Bartons Road, Havant

24-097-RPT 008 Rev A

Response Note to HCC Lead Local Flood Authority

December 2025

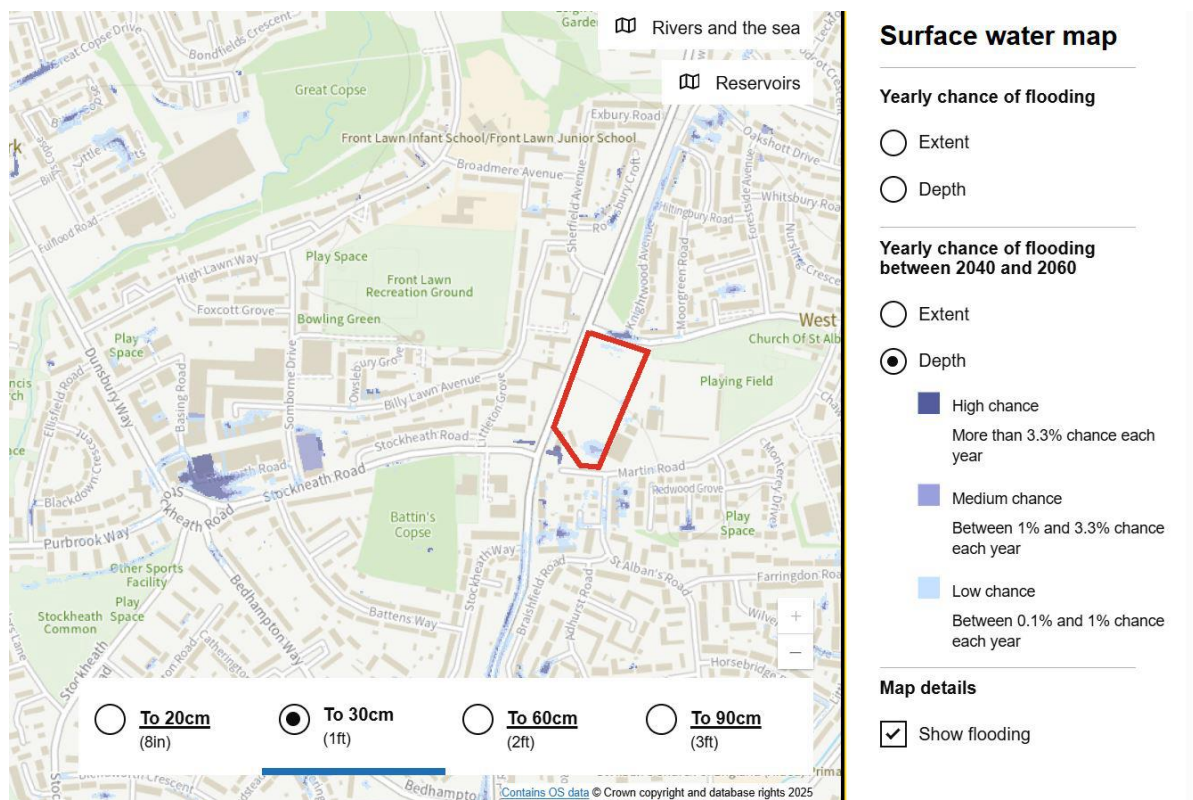
- 3.1.1 The FRA identifies a surface water flood flow path running through the site, along the western boundary, together with some separate localised areas of surface water flooding within the site. The LLFA expressed concern about the accuracy of the flood mapping used to determine this and suggest that flood modelling may be required to properly assess the impact of this flood risk on the development. The EA's "Flood Map for Planning" website was used to determine the route and extent of this flow path and the other surface water flood risk areas.

- 3.1.2 This, as the website suggests, is deemed sufficient to assess flood risk at planning stages of developments and therefore it is considered that the FRA adequately assesses the flood risk posed by the existing surface water flow path. This path will be maintained free from any built development and there will be no drainage attenuation features located within this flow path.

- 3.1.3 The LLFA also suggest that there may be a loss of flood storage on the site due to construction of the development. As noted above the surface water flow path which currently crosses the site will continue to do so unhindered and at the same ground levels so the construction of the development will not impact this flow route.

- 3.1.4 The above flood mapping also identifies some areas at potential risk from surface water flooding during extreme rainfall events. These are remote from the flow path and are the result of localised shallow surface water ponding within low lying areas on the site. Drawing 24-097 011 in **Appendix C** interpolated from the EA's flood map drawings shows the location of the surface water flow path in relation to the areas of on site ponding.

- 3.1.5 Figure 5-4 in the original FRA, see below, taken from the EA's published flood mapping, shows that the yearly chance of flooding from this localised ponding up-to 2060 is low, with only a small area in the south east corner of the site at risk of flooding to a depth of 30cm.
